Name Of Dam: LAUREL BED DAM

Inventory Number: VA 16701

LEVEL II
PHASE I INSPECTION REPORT
NATIONAL DAM SAFETY PROGRAM

BY
GILBERT ASSOCIATES, INC.

FIGURE 2
PLAN VIEW
LAUREL BED DAM
NO SCALE:

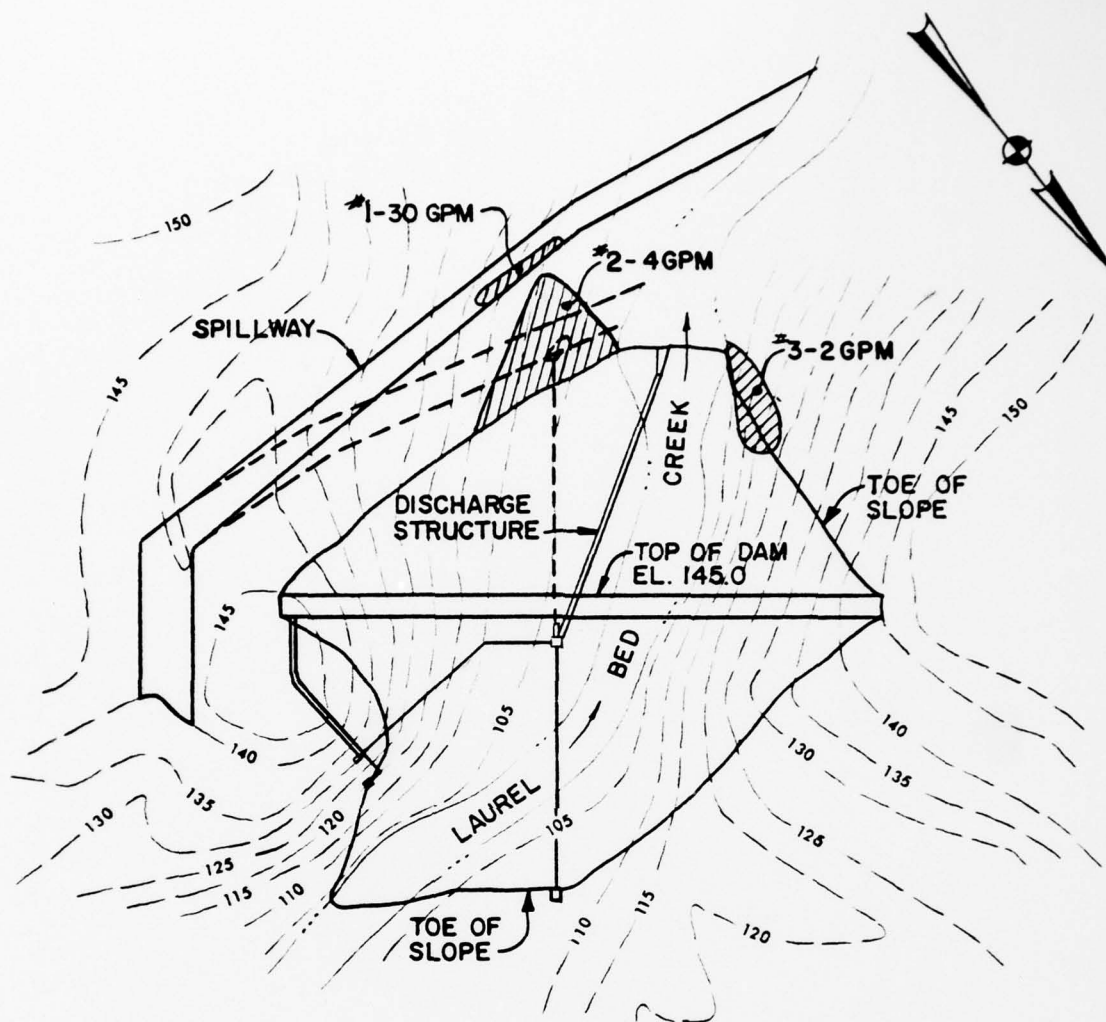
Some small differences were noted between the dam as constructed and the details shown on the plans. The downstream slope of the embankment is steeper near the top than is shown on the plan. It appears that during construction the fill for the downstream toe of the dam was started too close to the centerline of the dam. As the height of the fill increased it may have become necessary to steepen the slope in order to achieve the required top width. The spillway shaft is 36 inches rather than 42 inches, and the principal spillway crest appears to have been constructed 1 foot lower than the 140.0-foot elevation shown on the plans. The location of the spillway chute and outlet discharge point were also changed as shown on the Plan View in Appendix I.

The locations of both the emergency spillway chute and outlet discharge structure were different than shown on the plans. The approximate location as constructed is shown on the Plan View in Appendix I.

Three seepage areas were observed and are shown on the Plan View in Appendix I. Area 1 is in the emergency spillway channel and Area 2 is on the abutment slope about 70 feet below the dam crest. Although the seepage in areas 1 and 2 appeared to be from the same source, the temperature of the water in the spillway was 49°F and that on the adjacent abutment slope was 56°F. The seepage was estimated at 30 g.p.m. in the spillway and at 4 g.p.m. on the slope. The water was clear in both locations, but the larger flow in area 1 is causing some erosion in the spillway chute. Area 3 was the smallest area with a flow estimated at 1 to 2 g.p.m. It is located near the toe of the dam on the right abutment.

UPSTREAM FACE OF DAM SHOWING PRINCIPAL SPILLWAY
AND DETERIORATING RIPRAP

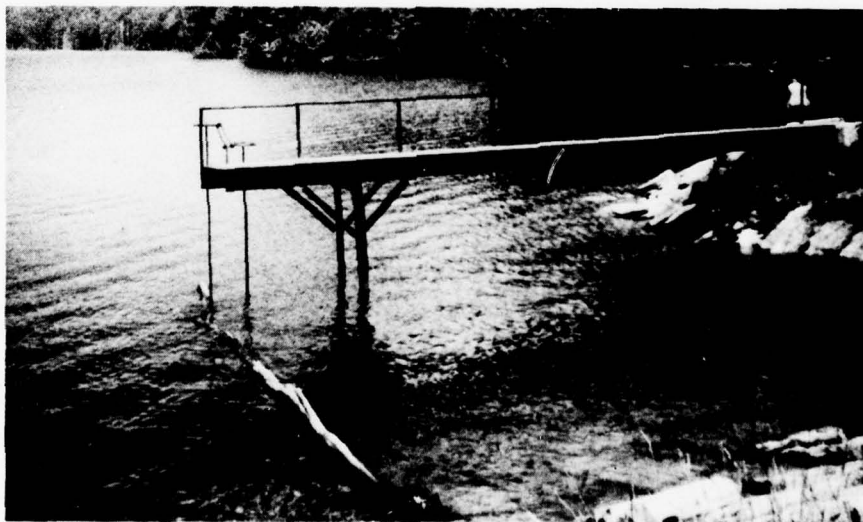
The riprap consisted of large flat stones scattered about the upstream slope. There were gaps of unprotected areas between the stones and there did not appear to be a filter layer between the riprap and the embankment material. It would appear that the original stone layer had been scattered by waves and ice, but there was only minor erosion of the embankment.

The top width of the embankment is also too narrow according to U.S. Bureau of Reclamation (U.S.B.R.) guidelines (Reference 3). The riprap protection of the upstream slope appears to be deteriorating, but erosion so far has been slight. This condition should be monitored and corrected if it worsens.

7.2.4 Inspection Program: We recommend that the Owner establish a semi-annual inspection program to monitor the conditions at the dam. Particular attention should be given to monitoring seepage rates and wear of the riprap on the upstream face of the dam.
